## Collins Cap Quarry

Quarry Intensification Water Quality Responses

Prepared for  
**Alltas Engineering PTY LTD**

## 5. Response to EPA Table of Issues Point 31

Figure 2: Major Site Drainage Features (drains blue, culverts green, bunding orange lines, catchments red)

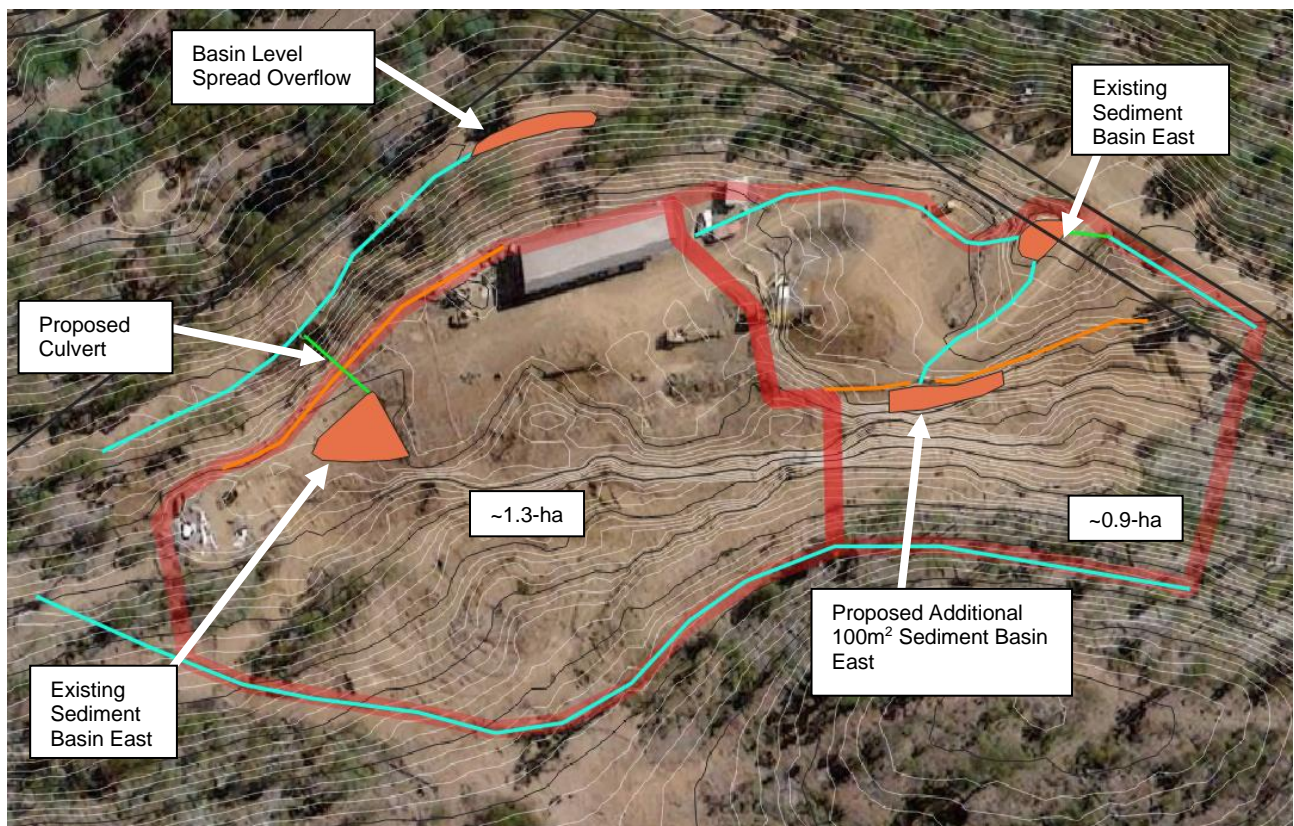
| 31 | 2. Water quality | 19 | <p>Surface water is seen pooling in the EER photos in many locations on site. Surface water management needs appropriate engineering to address hazards associated with offsite water discharge and overall slope stability management.</p> <p>It is advised that a copy of the drainage and catchment plan prepared by the geological engineer and referred to in the EER is included as an appendix to clarify the location of the drainage works and control measures implemented to manage the stormwater run-off from the site. Further information is required confirming the landslip hazard at the site has been adequately addressed and potential impacts to the water quality in the Glen Dhu Rivulet catchment are mitigated. The assessment must be in accordance with the Australian</p>   |
|    |                  |    | <p>Geomechanics Landslide Risk Guidelines <a href="https://landsliderisk.org/wp-content/uploads/2017/04/lgs_2007c2.pdf">https://landsliderisk.org/wp-content/uploads/2017/04/lgs_2007c2.pdf</a>.</p> <p>For sediment basins, provide the sediment capture particle size, settling volume and surface area calculations and design rationale. Refer to the EER Guidelines for more information and reference for suitable design approaches. Sufficient information is required to demonstrate the sumps are located and designed following best practice design principles.</p> <p>The EER notes that 'overflow from this sediment trap flows into the roadside culvert' (page 19). This has the potential to result in off-site discharge of total suspended soils. Please confirm the location of the overflow and the water quality entering the culvert.</p> <p>The EER states that 'there is to be a 300mm overflow pipe installed to direct excess water to the perimeter sediment pond on the lower side of the site.'. Please confirm if this pipe has been installed and whether this solution has been successful. Please clarify how overflow from the sediment pond is currently managed if these works have not been undertaken.</p> <p>Describe the potential impacts of stormwater to the receiving environment, including the neighbouring dams.</p> |

With reference to Figure 2 the red gravel quarry has and is proposed to have two main catchments with the following features:

- A catch drain on the southern edge (top of the quarry) is currently in place and is proposed to be extended to capture “clean” surface water from above the site and divert it west around the quarry area

- Bunding and drains are present through the quarry and direct surface water to two sediment basins as seen in Figure 1
- Overflow from the sediment basins are proposed to discharge to:

- The existing eastern basin near the entrance discharges into a road drain on Collins Cap Road (immediately north of the basin)
  - An additional sediment basin is recommended in the eastern catchment as the existing basin is not adequately sized to meet best practice

- The existing western basin overflow discharges via a 300mm overflow pipe to the north and into an existing level spread discharge basin; and
- Contours presented are derived from LiDAR surveyed in 2019 (WellingtonRange2019-DEM-1m), noting that changes have occurred due to quarrying activities in the period since.

- The existing sediment basin for catchment 1 has a size and geometry that is not adequate in surface area when compared to best practice guidelines (currently ~60m<sup>2</sup> vs recommended 130m<sup>2</sup>). It is recommended that either:
  - The basin surface is increased to 130m<sup>2</sup>
  - An additional basin of 100m<sup>2</sup> is provided in a suitable location (recommended location and size presented in Figure 2), geotechnical input must be provided pertaining to the final location of the basin to ensure the stability of adjoining areas, and / or
  - Drains on upper benching are redirected to sediment basin 2 and the effective catchment area 1 is reduced; and
  - Additionally, internal drainage paths must be directed through the basin particularly near the Collins Cap Road entrance.

- The existing sediment basin for catchment 2 has a size and geometry consistent with best practice guidelines for the proposed intensification of quarrying activities; and
- The overflow pipe from this sediment basin should be constructed to direct flow north into the existing catch drain. A rock lined chute is recommended at the culvert outlet to protect the existing embankment, engineering input for the culvert and chute design is recommended to ensure the existing embankment is appropriately protected.

- The sediment basin nearest Collins Cap Road has been assessed with the current arrangement not adequate to meet best practice guidelines. A recommendation to increase the size or add additional basin upstream has been provided along with recommendation to ensure the entire catchment is directed into the existing or additional basin and overflow is via a rock lined spillway onto Collins Cap Road

- If not already installed, an overflow pipe from the western sediment basin is recommended to provide a controlled outflow; and
- The proposed arrangement will have minimal impact on the two small dams immediately north of the quarry when compared to the existing arrangement. The current site drainage outfalls are not directed into these dams and the proposed arrangement does not alter this. Flow will eventually migrate to other farm dams via Collins cap Road drains and culverts however best practice management is proposed to control the quality of the discharge.
